**COMMUNICATION – C57**  
**ITEM 1**  
**Committee of the Whole (Public Meeting)**  
**October 29, 2020**

**VAUGHAN COMPREHENSIVE ZONING BY-LAW - THIRD DRAFT - 2748355 CANADA INC., MOBILIO DEVELOPMENTS LTD., AND RP B3N HOLDINGS INC. COMMENTS**

On behalf of our clients, IBI Group wishes to provide the following comments on the Third Draft of the proposed Comprehensive Zoning By-law (CZBL). The intent of this letter is to highlight our main concerns and comments on the Third Draft of the CZBL.

**Figure 1. Landmark Locations from Schedule A2 of Zoning By-law 1-88**

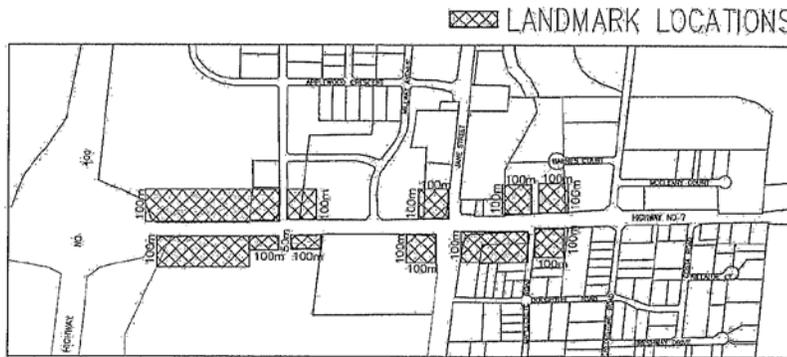
IBI Group would also like to highlight that notable provisions from Zoning By-law 1-88 are missing from the current Draft Comprehensive Zoning By-law, including the Landmark Location provision from Schedule A2 of Zoning By-law 1-88 (**Figure 1**). This provision permits unlimited height in certain locations along Highway 7 to serve as a gateway to the Highway 7 corridor. IBI Group is not supportive of the exclusion of these provisions from the Comprehensive Zoning By-law and wish to see them included in the Second Draft. Several towers have already been approved and/or constructed along Highway 7 within the Landmark Locations, setting a precedent for the built-form along this corridor. The removal of these provisions will create a disconnect between the built-form, conflicting with several of the City’s Urban Design objectives and creating great variations in height and density.

**Figure 1. Landmark Locations from Schedule A2 of Zoning By-law 1-88**

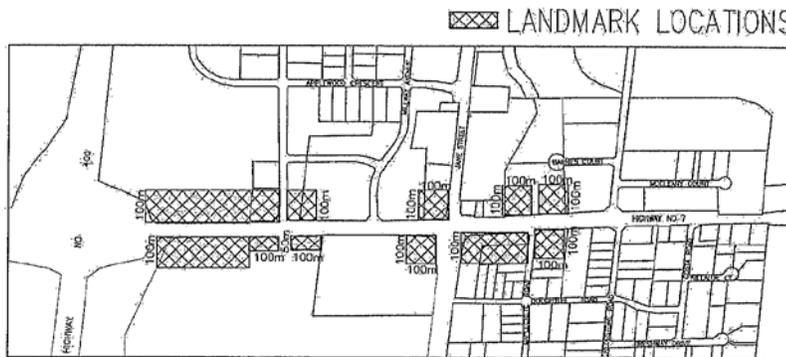
IBI Group would also like to highlight that notable provisions from Zoning By-law 1-88 are missing from the current Draft Comprehensive Zoning By-law, including the Landmark Location provision from Schedule A2 of Zoning By-law 1-88 (**Figure 1**). This provision permits unlimited height in certain locations along Highway 7 to serve as a gateway to the Highway 7 corridor. IBI Group is not supportive of the exclusion of these provisions from the Comprehensive Zoning By-law and wish to see them included in the Second Draft. Several towers have already been approved and/or constructed along Highway 7 within the Landmark Locations, setting a precedent for the built-form along this corridor. The removal of these provisions will create a disconnect between the built-form, conflicting with several of the City’s Urban Design objectives and creating great variations in height and density.

**Figure 1. Landmark Locations from Schedule A2 of Zoning By-law 1-88**

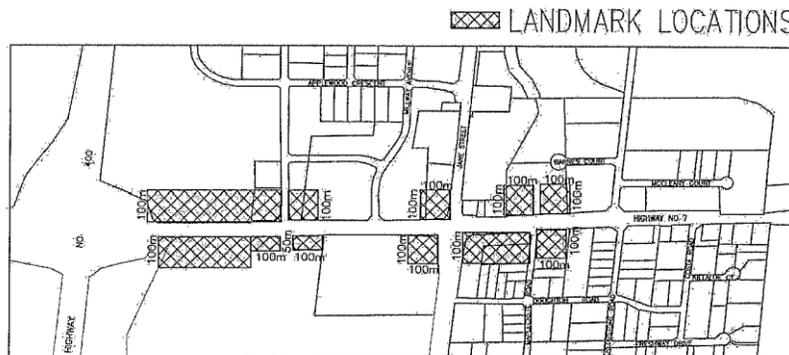
IBI Group would also like to highlight that notable provisions from Zoning By-law 1-88 are still missing from the Second Draft Comprehensive Zoning By-law, including the Landmark Location provision from Schedule A2 of Zoning By-law 1-88 (**Figure 1**). This provision permits unlimited height in certain locations along Highway 7 to serve as a gateway to the Highway 7 corridor. IBI Group is not supportive of the exclusion of these provisions from the Comprehensive Zoning By-law that essentially downzone the parcels and wish to see them included in the Final Draft. The removal of these provisions will create a downzoning that is inconsistent with provincial policy related to urban growth centres and MTSAs.
